Broadcast Products Technical Bulletin 20-2004-086

SUBJECT: REUSE ICs WHEN REPLACING HZ BOARD

MODEL: **BVM-1311**
BVM-1316
BVM-1316C
BVM-1411P
BVM-1911
BVM-1916
BVM-2011P

Figure 1

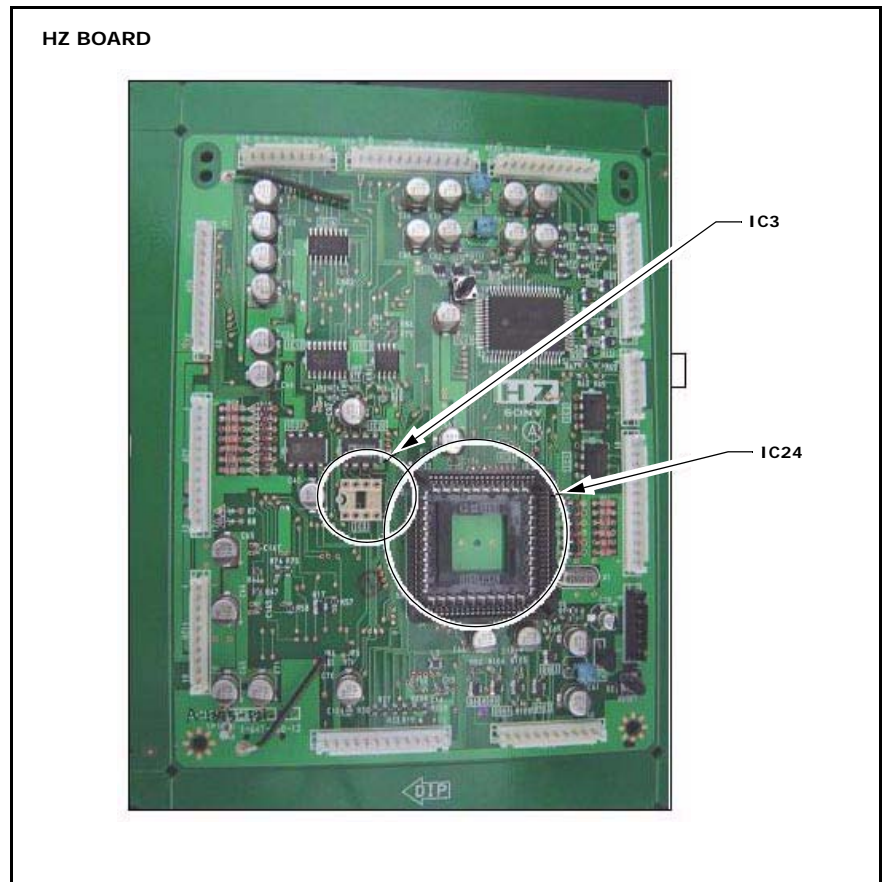
When you replace the HZ board (A-1375-121-A), remove the following ICs from the former board and install them on the new board.

IC	Description
IC3	ICX25040P
IC24	ICHD6475368-BVM1.20

The new HZ board does not contain the ICs, and the ICs are no longer available as service parts. (See Figure 1.)
